Office Action Summary	Application No. 10/599,983	Applicant(s) MAEDING, CHRIS	
	Examiner PHUTTHIWAT WONGWIAN	Art Unit 3741

DETAILED ACTION

9. Claims 6-25 are rejected under 35 U.S.C. 102(b) as being anticipated by Vuillamy (US Patent No. 5, 404, 715).

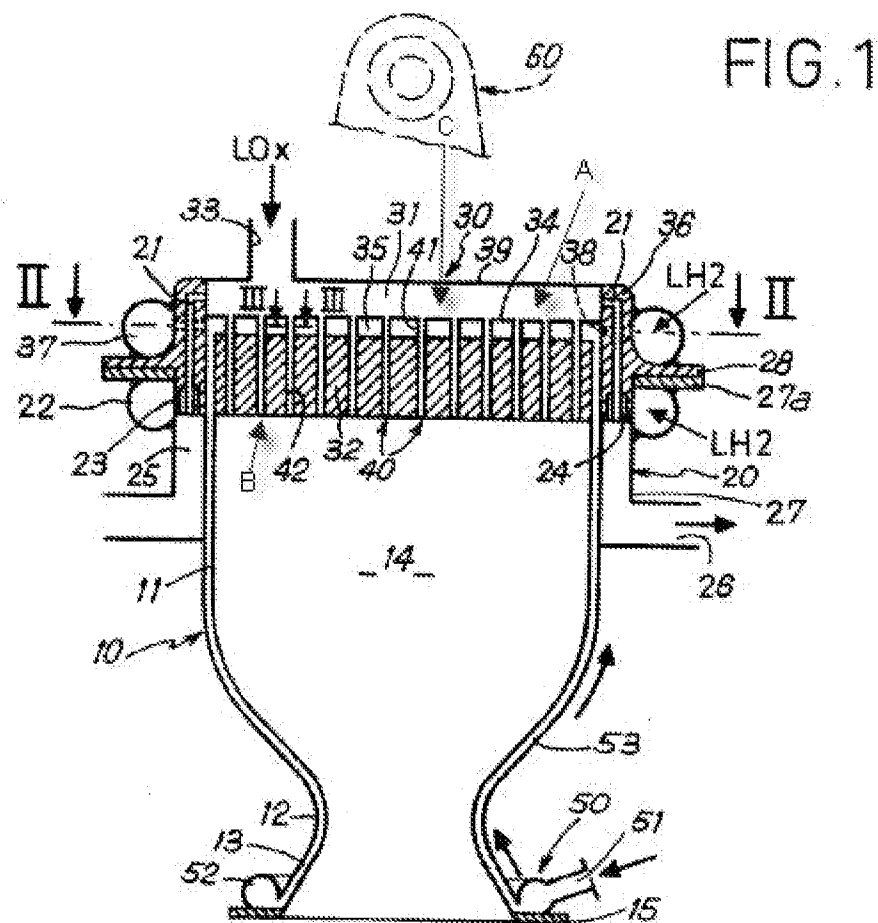
10. As to claim 6, Vuillamy discloses a device (fig. 1) for [intended use] damping oscillations of a combustion chamber comprising: at least one resonator structured 132 or 136 (fig. 4) and arranged to dampen vibrations being connected to a pre-chamber 31 (fig. 1), wherein the pre-chamber is connected to a combustion chamber 14 (fig. 1) via at least one passage channel 40 (fig. 1, the channel of 40).

11. As to claims 7-13, Vuillamy discloses the combustion chamber 14 (fig. 1) adjoins an injection head A (fig. 1 above) having at least one injection element 40 (fig. 1), wherein the injection head conducts a fuel flow (col. 7, line 16-20, "a coaxial injector 40 may comprise an outer tube 42 co-operating with an inner tube 41 to define an annular fuel feed channel") into the combustion chamber 14 (fig. 1), wherein the pre-chamber 31 (fig. 1) is arranged upstream of the at least one injection element 40 (fig. 1), wherein the pre-chamber 31 (fig. 1) is arranged in an area of the at least one injection element 34 (fig. 1), wherein the pre-chamber 31 (fig. 1) is in fluid connection with a fuel flow col. 7, line 16-20, "a coaxial injector 40 may comprise an outer tube 42 co-operating with an

inner tube 41 to define an annular fuel feed channel"), wherein the at least one passage channel 40 (fig. 1, the channel of 40) is part of an injection element 34 (fig. 1) and wherein the combustion chamber 14 (fig. 1) is part of a rocket engine (abstract line 1-2, "The rocket engine").
